Georgetown Charter Township

Planning Commission Meeting Agenda

6.I. (PUD2003) Wesco Inc. (36th Ave./Baldwin PUD), Is Requesting Preliminary (For This Parcel Only Since The Preliminary Approval Has Expired And The Rest Of The Site Has Already Been Developed) And Final Planned Unit Development Approval For A Vehicle Service Station And Convenience Store On P.P. # 70-14-17-100-024, Located At 7661 36th Ave., Georgetown Township, Ottawa County, Michigan.

6.I.ii. (PUD) Wesco Staff Report

Designed By: CAG
Drawn By: EB
Checked By:
Date:
Plot:
Scale: 1" = 20'
Date: 08–12–2020
Job No.: 1910637.1A
Sheet No.: L–101B
14 of 14

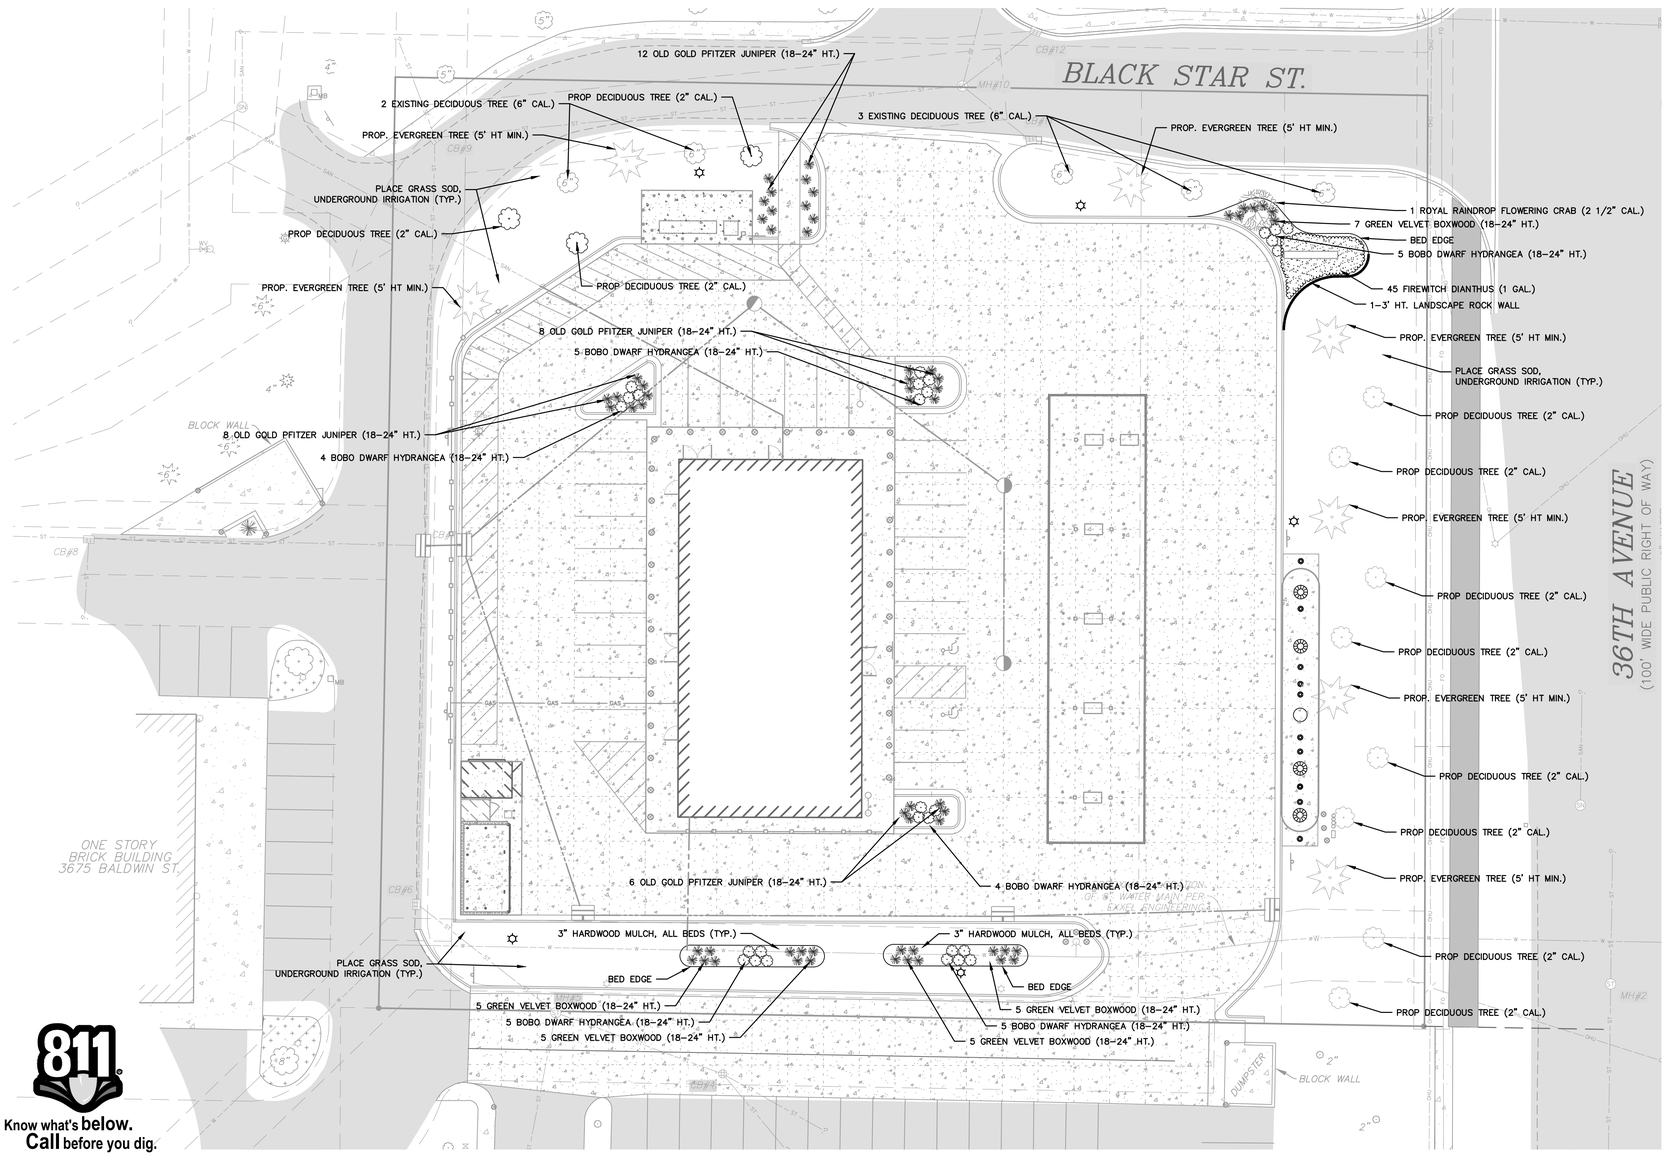
However, as noted on sheet V-101, there is an easement along 36th Ave. that prevents trees from being placed in the front setback, which are needed to meet streetscape requirements. The applicant has indicated that they are investigating having the easement vacated to allow the trees for the streetscape to be planted in the front setback area of 36th Ave.

A suggestion would be to approve the landscape plan shown on sheet L-101B and then if they are not allowed to plant the trees in the front setback area of 36th Ave., the same number of trees (size, etc.) could be required to be planted elsewhere on the site.

d. The location, type and size of all proposed landscaping and site amenities (art work, fences, gateway features, etc.). **PROVIDED. However, it is noted on sheet V-101 that an easement prevents trees from being planted in the front yard setback on 36th Ave. A recommendation is to approve sheet L-101B which shows the required trees along 36th Ave., and to stipulate that if the required number of trees cannot be placed in the front yard setback on 36th Ave., they would be required to be placed elsewhere on the site.**

d. Should the landscape plan shown on sheet L-101B be approved with the contingent plan that if the easement is not vacated and trees are not allowed to be planted in the front setback area of 36th Ave., the same number of trees (size, etc.) shall be required to be planted elsewhere on the site?

A3.01

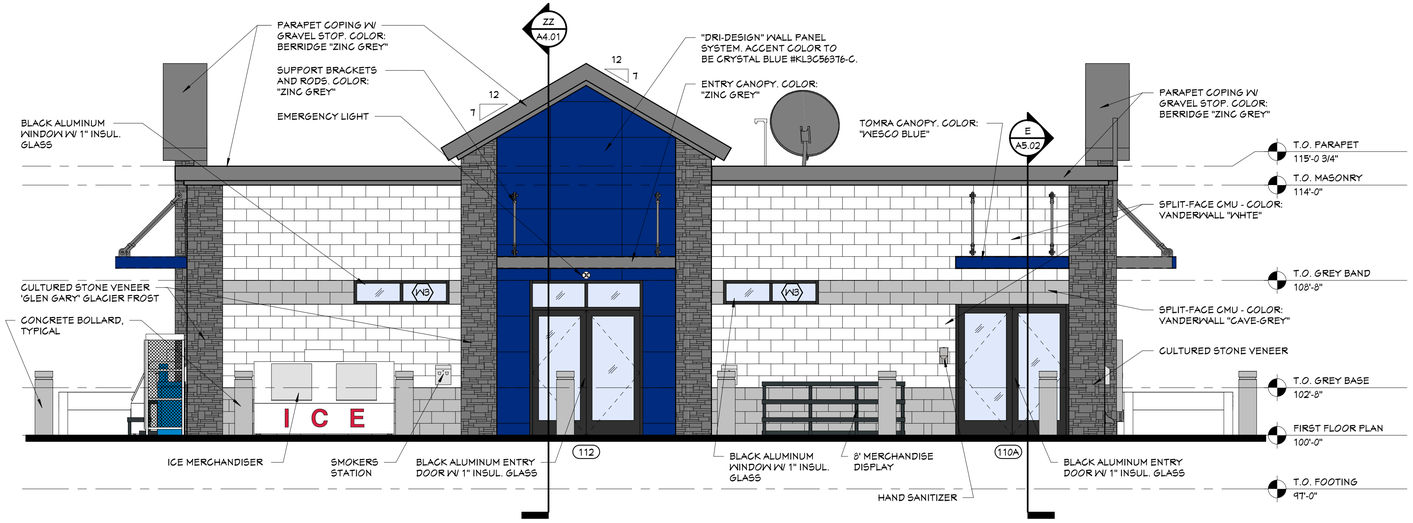
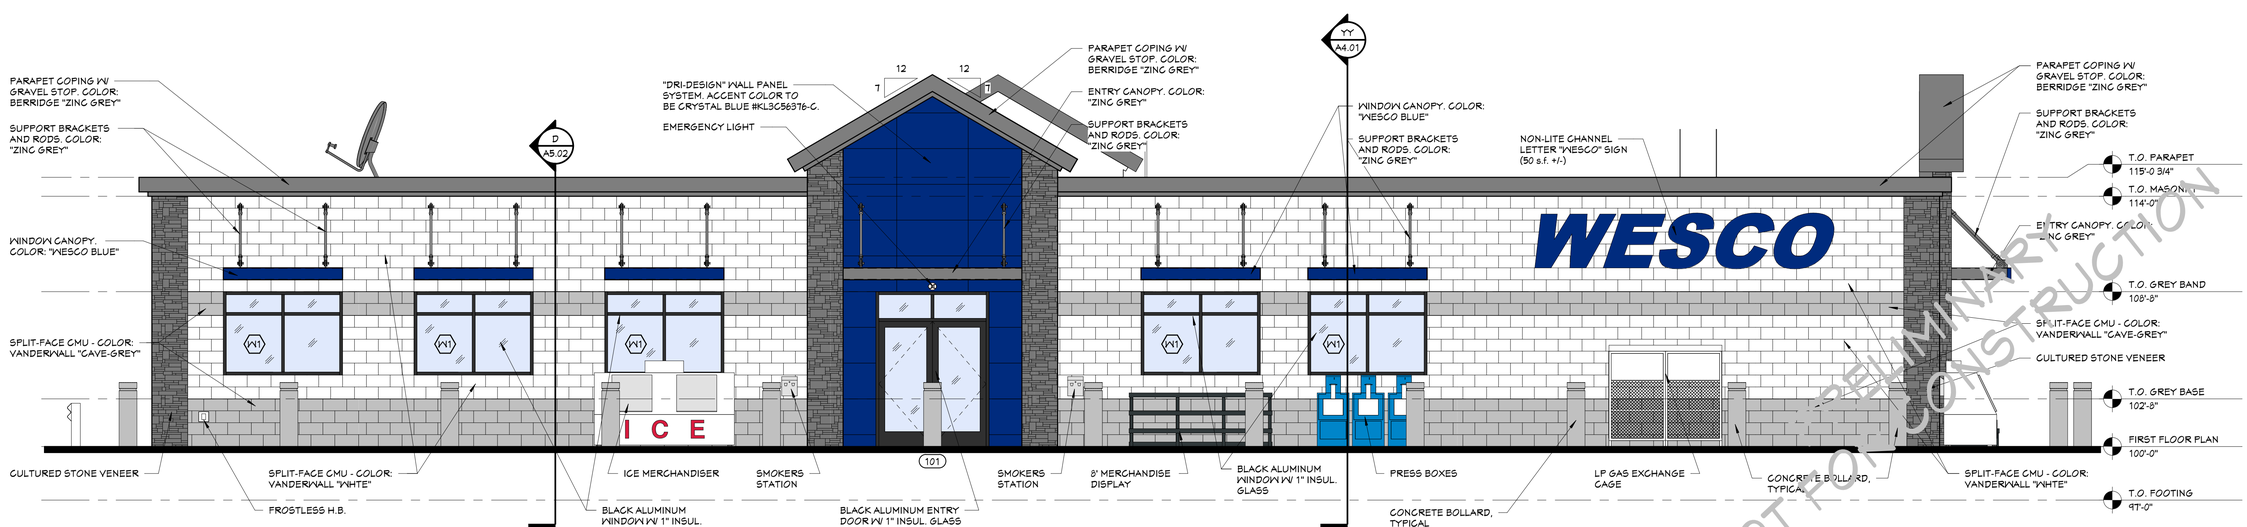
PROVIDED for lighting. PROVIDED FOR SIGNS. The signs can stay on the pumps (sheet (C-503), like all other gas stations have. Details were not provided for the wall sign shown on sheet A3.01 and all wall signs shall meet ordinance requirements. Sec. 25.6(B) allows to be 1 ½ times the lineal frontage of the wall it is to be placed upon (max 200 SF).

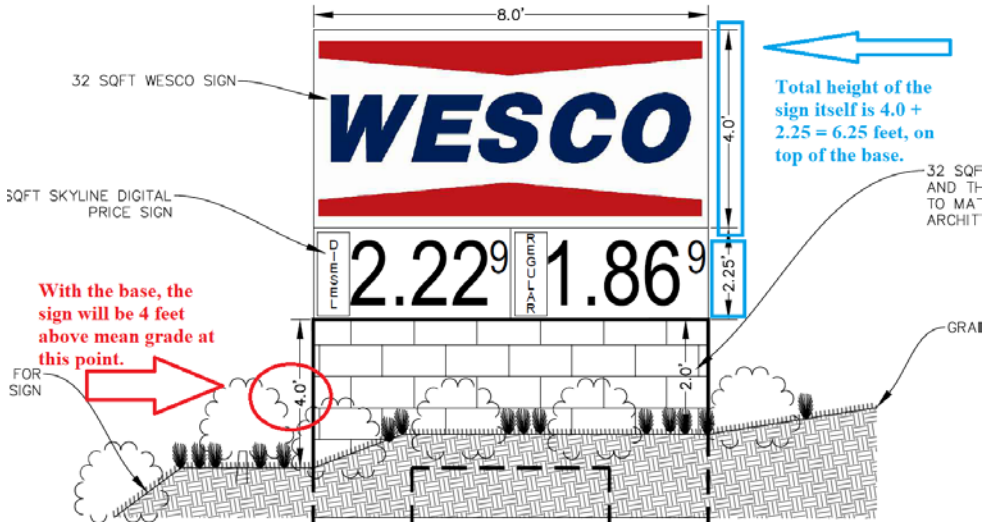
c. First, a ground mounted sign is to be situation directly on the ground; however, due to the major elevation change (which slopes down), the request is to have the ground mounted sign elevated to be four feet high from the sidewalk elevation, which is actually higher than 4 feet when measured from the mean grade. The sign is proposed to be 50 square feet. **Is this acceptable**? Second, the ordinance only allows a ground mounted sign to have a height of 4 feet and they are proposing for the sign itself (not the frame) to be 6.25 feet in height. The "Wesco" part is 4 feet and the fuel prices part is 2.25 feet. **Is this acceptable**?

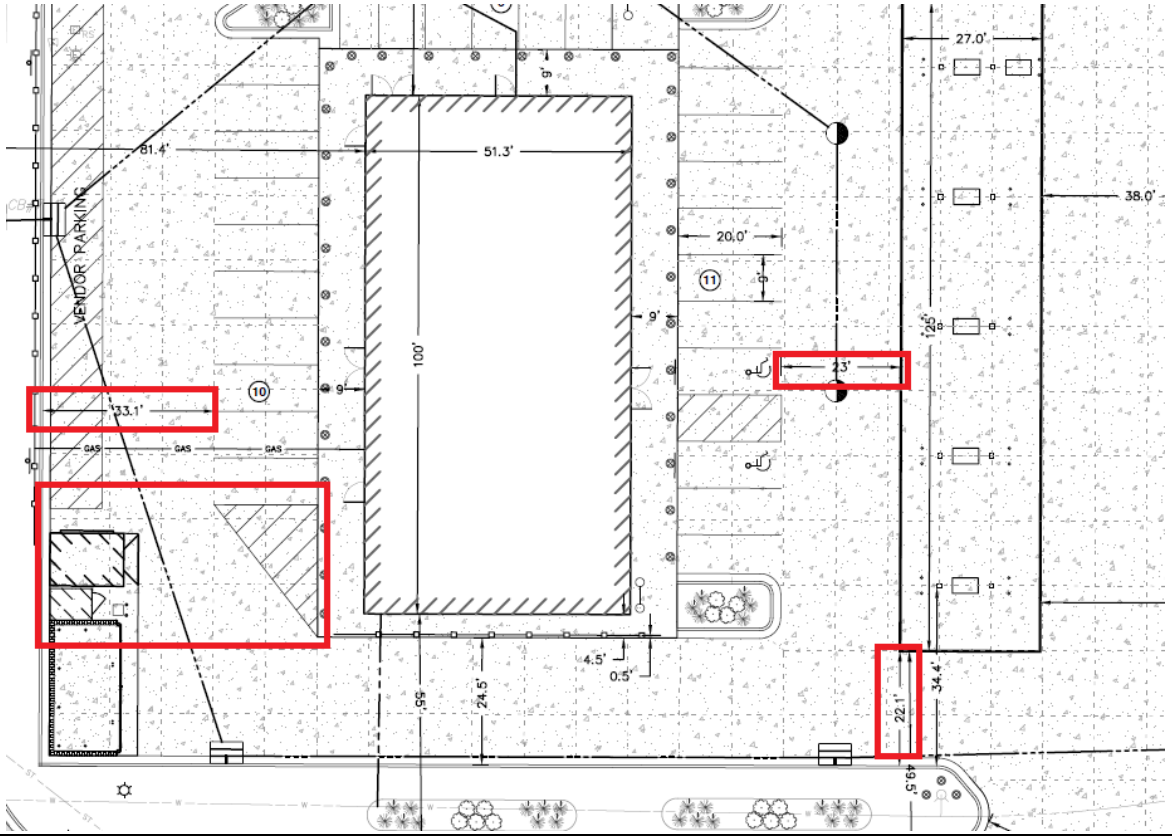
e. **A deviation request is also noted for the drive aisles. Three locations on the site do not meet the 24 foot drive aisle requirement for two way traffic. Note, if these dimensions are not acceptable, direction could be given for them to be widened and administratively approved.**

1) **On the west side of the building, 31 feet is noted from the edge of the parking spaces to the western curb. However, there is a choke point where the aisle narrows between the parking spaces which looks to be significantly less than the minimum required 24 feet.**
2) **On the south side of the canopy, the distance from the canopy to the curbed area is only 22 feet and the applicant is requesting deviation approval for the area under the canopy to be counted toward that 24 foot requirement. However, consider that there may not be room if a vehicle is at the southern-most gas dispenser.**
3) **On the east side of the building between the end of the parking spaces and the canopy is only 23 feet. Again, a vehicle could be parked at the dispenser and prevent the two way traffic.**

e. Should the plan be redrawn for the drive aisle widths? Or are any acceptable? If a redrawing is necessary, could it be administratively approved?
